## **TECHNICAL INFORMATION LETTER**

TIL N°	T-139-22-007	
DATE:	August 05, 2022	
REV.:	/

## SUBJECT: Tail Rotor Sliding Control Assy install and remove procedures

Helicopters Affected: AB/AW139

Figure 1 – Sliding Control Assy installation

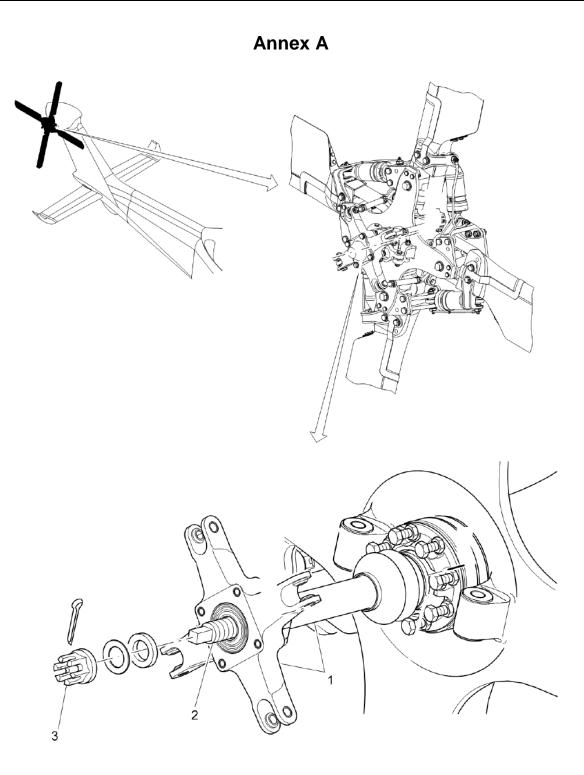
In particular, Reference [1] and [2] provide the necessary instructions to perform respectively the installation and the removal of the Tail Rotor Sliding Control Assembly (item (1) of Figure 1, Annex A) by acting on the Special Nut (item (3)) and the Control Rod of the Tail Rotor Actuator (item (2)).

- Highlight the importance to follow the instructions requiring to lock the Control Rod (2) to prevent it to turn during the installation/removal of Special Nut (3), introducing a dedicated Caution.
- Recommend that the installation/removal of the Special Nut (3) on/from the Control Rod (2) is performed by two persons (one locking the Control Rod (2) and one installing/removing the Special Nut (3) to prevent the Control Rod (2) to turn).
- Verify that no turning of the Control Rod (2) occurred during the installation of the Special Nut (3).
